**RESOLUTION NO. 16-91**

TOLL 49 SEGMENT 4 IMPROVEMENTS PROJECT

CHANGE ORDER NO. 2

**Mile Markers Toll 49 - Options A & B**

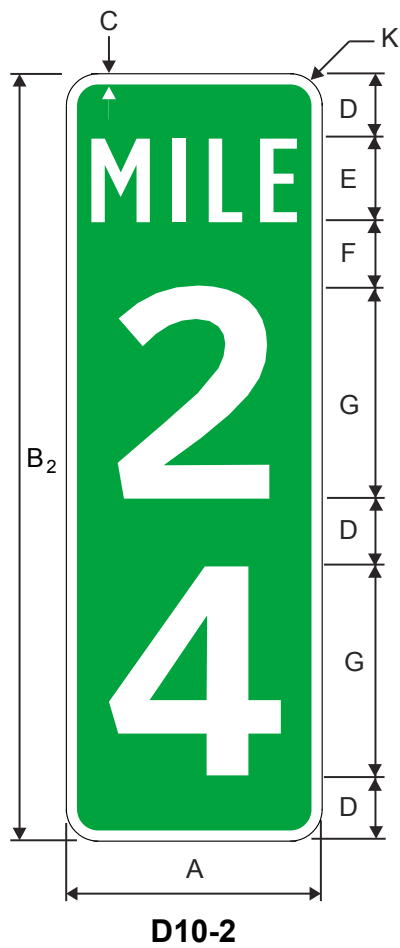
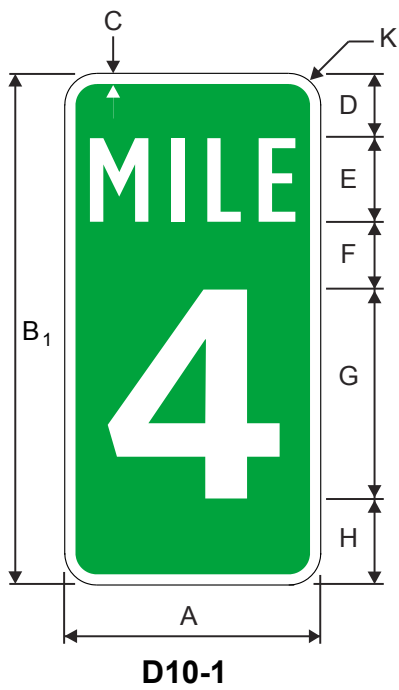
<b>Project Information</b>		<b>ISSUANCE DATE: 10/03/2016</b>
Project Name	Toll 49 Segment 4 Improvements	
CSJ	3487-01-017, 3487-01-018	
Owner	North East Texas Regional Mobility Authority (NET RMA)	
<b>Description and Reason for the Change Order</b>		
<p>NET RMA has opted to add mile markers along the Toll 49 facility. The limits of this work are from US 69 north of Lindale, TX to SH 110 south of Tyler. Webber submitted the price proposal to furnish and install 66 mile markers along the southbound and northbound Toll 49 alignment.</p> <p>The contractor provided pricing for two assembly options: Option A: 10 BWG 1 SAP mile marker (single sided) and Option B: TWT 1 WAP mile marker (single sided). Option A is recommended to provide a longer life cycle and require less maintenance costs in the future.</p> <p>The pricing was compared and the proposed costs were found to be lower than TxDOT statewide averages for this item. NET RMA has reviewed the proposal and it appears the costs are reasonable and recommends approval.</p>

Selected  
Option A

SUBCONTRACTORS					
DESCRIPTION	QTY	UNIT	RATE	AMT	
<b>Mile Markers - Option A</b>					
10 BWG 1 SAP mile marker (single sided)	66	EA	\$ 375.00	\$ 24,750.00	
				\$ -	
				\$ -	
TOTAL SUBCONTRACTOR COST					\$ 24,750.00
5% SUBCONTRACTOR MARKUP					\$ 1,237.50
SUBTOTAL					\$ 25,987.50
1% BOND					\$ 259.88
<b>SUBCONTRACTOR TOTAL</b>					<b>\$ 26,247.38</b>
<b>TOTAL COST</b>				<b>\$ 26,247.38</b>
